**MISSISSIPPI DEPARTMENT OF TRANSPORTATION
TABLE OF CONTENTS**

PROJECT: HSIP-9999-01(254)/107530301 - District 1

SECTION 904 – NOTICE TO BIDDERS NO. 1064

SUBJECT: Plan Corrections

MISSISSIPPI DEPARTMENT OF TRANSPORTATION	
AERIAL SUPPORTED CONDUIT	
FIBERGLASS (FRP) CONDUIT	
NOTES AND TYPICAL DETAILS	
PROJ. NO.: UPDATE	
COUNTY: DATE	
FILENAME: DWG.dwg	
DESIGN TEAM	UPDATE
CHECKED	DATE
DATE	3

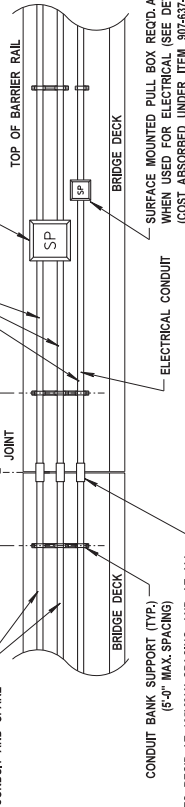
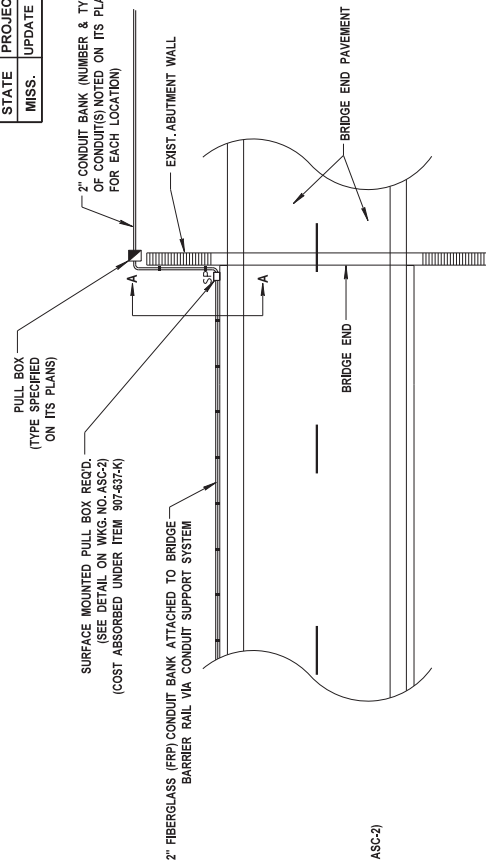
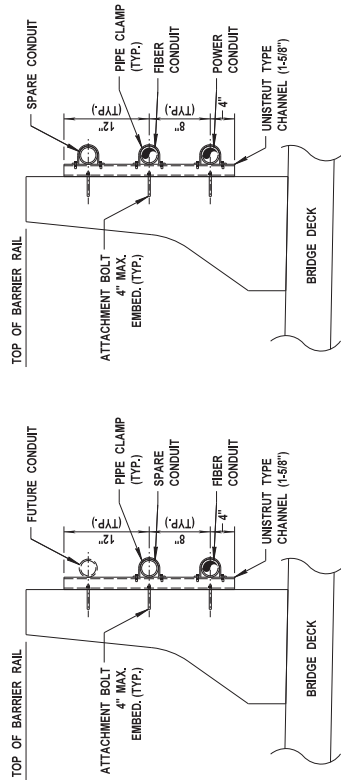
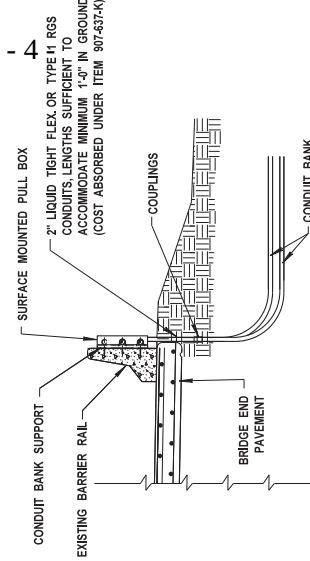
Bidders are advised that at Site 1 (US 82 at SR 389), an additional Type 2 Pullbox on the Northeast side immediately before the 389 bridge will be required. From this location, Type 1 Rigid Conduit will run aerially along the bridge and tie into the Pullbox that is shown on the South side of the bridge. To achieve this, the following changes have been made to the bid sheets.

- Pay item no. 907-637-A002, Pullbox Enclosure, Type 2, is shown as having a quantity of 39 Each. This is in error. The correct quantity is **40 Each**. The bid sheets are correct.
- The Scope of Work does not include pay item no. 907-637-F005, Traffic Signal Conduit, Aerial Supported, Type 1, 2". A Quantity of **500 LF** has been added to the bid sheets. Conduit is structure-attached conduit and includes all hangers, expansion assemblies, and surface-mounted pullboxes. See attached drawings for details.
